# Access Compliance Report

## Public Rights-of-Way

### (Curb Ramps)

Intersection ID: 47968	Main Street: MESA_VERDE_RD	Cross Street: KYRENE_RD	Location: SW
ADA ID: 0BDC38AF1D75	Ramp Type: PerpDiag	Initial Pass/Fail: Fail	Overall Compliance: No
Severity Score: 8.75			
Codes/Mitigation Info/Possible Solution		Field Measurements/Component Compliance

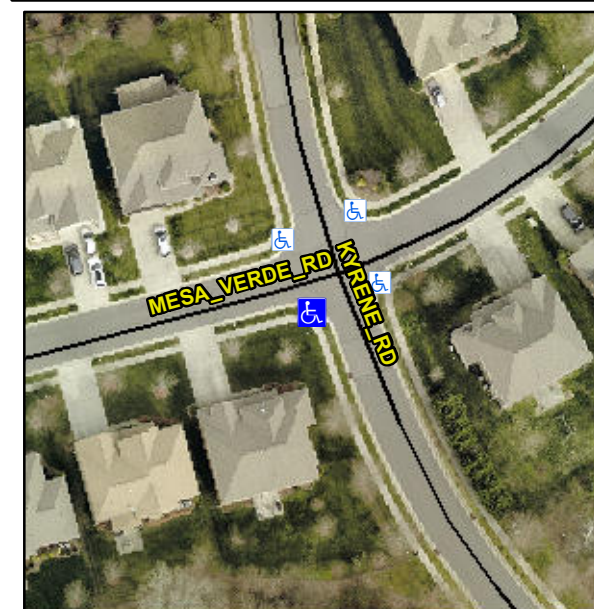
Compliance	Description	Data	Compliance	Description	Data
N/A	Ramp Length (in)	49.0	Yes	Ramp Slope (%)	6.8
No	Ramp Width (in)	46.5	Yes	Ramp XSlope (%)	0.5
N/A	Flare Type LT	N/A	N/A	Flare Type RT	N/A
N/A	Flare Slope LT (%)	N/A	N/A	Flare Slope RT (%)	N/A
N/A	Flare Traversable LT?	N/A	N/A	Flare Traversable RT?	N/A
N/A	Landing Length (in)	N/A	N/A	DWS Provided?	N/A
N/A	Landing Width (in)	N/A	N/A	DWS Contrast?	N/A
N/A	Landing Slope (%)	N/A	N/A	DWS Length (in)	N/A
N/A	Landing X Slope (%)	N/A	N/A	DWS Full Width?	N/A
N/A	Landing Curb? (Y/N)	N/A	N/A	DWS Offset (in)	N/A
N/A	Shared Landing?	N/A			
N/A	Gutter Ponding?	N/A	N/A	Gutter Slope (%)	N/A
N/A	Gutter Lip Ht (in)	N/A	N/A	Gutter X Slope (%)	N/A
N/A	Painted X Walk1?	No	N/A	Painted X Walk2?	No
	X Walk 1 Direction	To E		X Walk 2 Direction	To N
N/A	X Walk 1 Width (in)	N/A	N/A	X Walk 2 Width (in)	N/A
	X Walk 1 Slope (%)	1.1		X Walk 2 Slope (%)	1.3
	X Walk 1 X Slope (%)	1.6		X Walk 2 X Slope (%)	1.2

N/A	Ramp inside XWalk1?	N/A	N/A	Ramp inside XWalk2?	N/A
	Road Slope (%)	1.8	N/A	Clear Space?	N/A
	Road X Slope (%)	1.3	N/A	Clear Space to XWalk (in)	N/A
N/A	Any Obstructions?	N/A	N/A	Storm Grate/Utility Hazard?	N/A
	Obstruction Type			Storm Grate/Utility Type	
		N/A			N/A
			Yes	Surface Condition? (G/P)	Good

**Remove & Replace Curb Ramp With Two New Directional Ramps or Equivalent.**

**R304.5.1**
